Serial No. 12-349
LIC/CDS/R0
Docket No. 50-305
License No. DPR-43

DOMINION ENERGY KEWAUNEE, INC.
KEWAUNEE POWER STATION
RESPONSE TO REQUEST FOR ADDITIONAL INFORMATION:
LICENSE AMENDMENT REQUEST 244, PROPOSED REVISION TO
RADIOLOGICAL ACCIDENT ANALYSIS AND CONTROL ROOM ENVELOPE
HABITABILITY TECHNICAL SPECIFICATIONS (TAC NO. ME7110)

**RESPONSE TO REQUEST FOR ADDITIONAL INFORMATION:
LICENSE AMENDMENT REQUEST 244, PROPOSED REVISION TO
RADIOLOGICAL ACCIDENT ANALYSIS AND CONTROL ROOM ENVELOPE
HABITABILITY TECHNICAL SPECIFICATIONS**

Figure 3.1-1 Kewaunee Source and Receptor Points

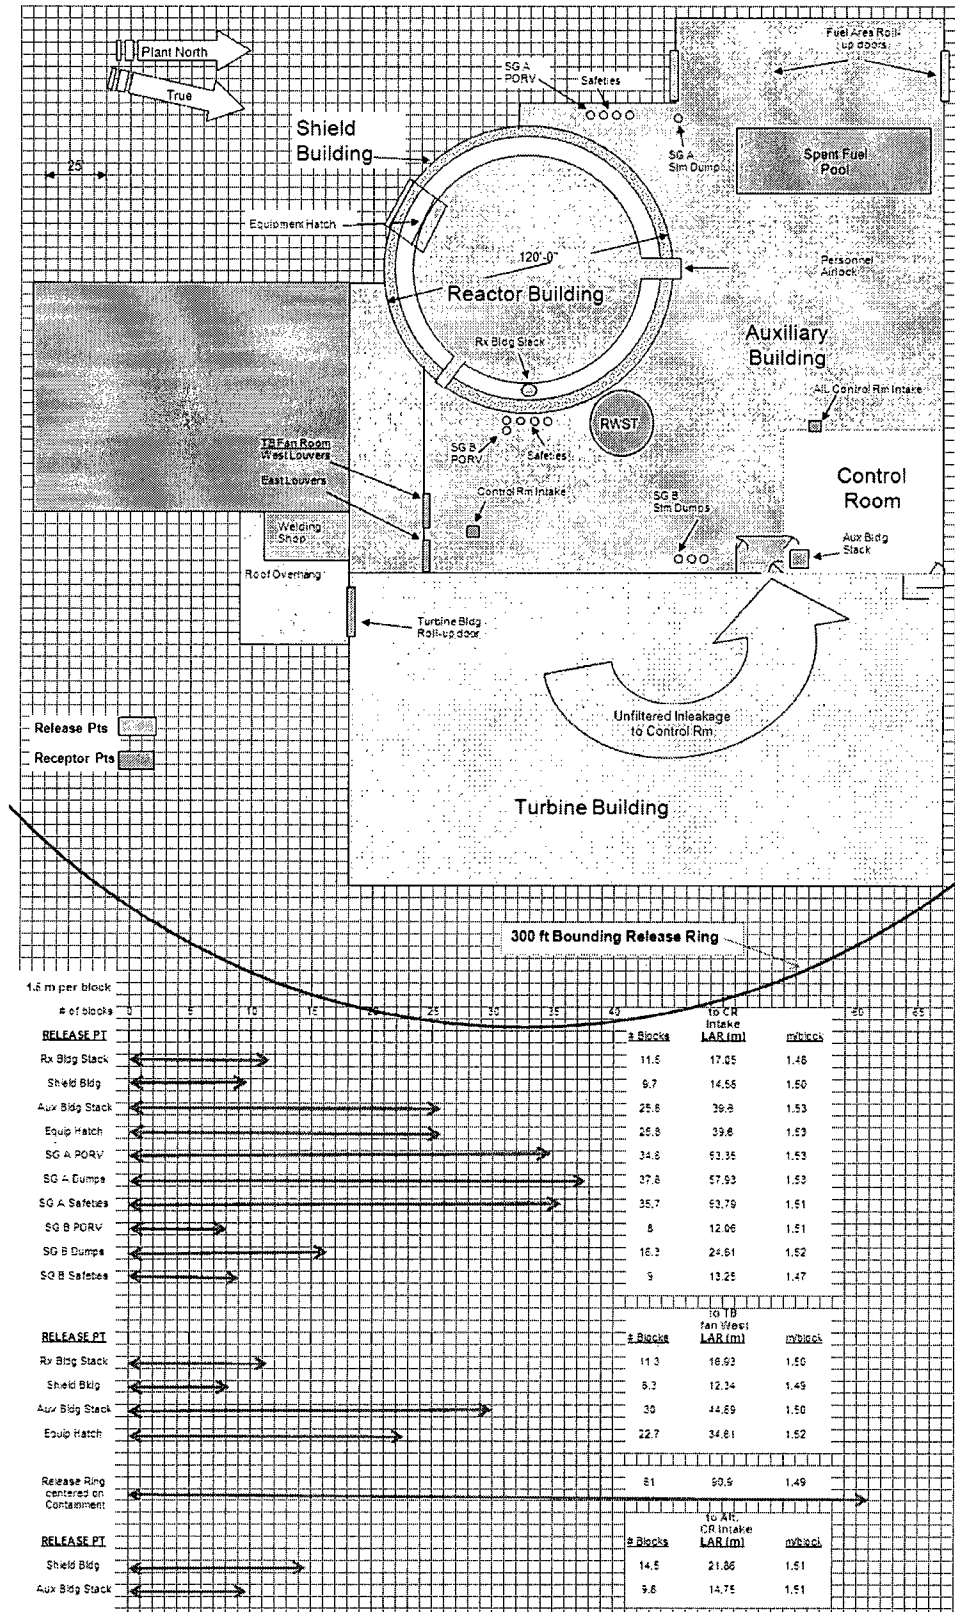
The LAR states that Figure 3.1-1, "Kewaunee Source and Receptor Points," of Attachment 4 provides a relative scaled drawing of the Kewaunee Power Station building orientation and control room location showing all identified release points and receptors. The figure is very informative, but does not appear to be drawn entirely to scale and/or to have all sources and receptors positioned on the figure based upon the scale. For example, Table 3.1-1, "Line-of Sight Horizontal Distance from Source to Receptor," of Attachment 4, lists the distances from the "SG [steam generator] B PORV [power operated relief valve]" and "SG B Dumps" to the Control Room Intake as 12.06 meters (m) and 24.81 m, respectively. However, in Figure 3.1-1, the SG B Dumps appear to be slightly closer to the Control Room Intake than the SG B PORV. Please revise Figure 3.1-1 to provide the scaled position of each source and receptor, as appropriate, to confirm the information provided in Table 3.1-1 and Table 3.1-2, "Direction from Receptor to Source," of Attachment 4.

- a. With regard to Figure 3.1-1, where is the alternative CR intake?
- b. Describe the conditions under which its use is permitted.
- c. Provide the inputs to the CR atmospheric dispersion factor (X/Q value) estimates for each design basis accident which could occur when the alternative CR intake is in use.

Figure 3.1-1 was revised and scaled to more accurately identify the physical orientation of release points and receptors. The revised Figure 3.1-1 is provided below.

- a. Figure 3.1-1 was revised to include the identification where the alternative CR intake is located. See response to Question 5 above.
- b. There is no longer any condition for which the alternate control room intake will be used and administrative controls will be in place to prohibit the use of the alternative CR intake and applicable procedures will be revised accordingly. For additional information regarding maintaining the alternate CR intake closed at all times see DEK response to Question 9 in Reference 4.
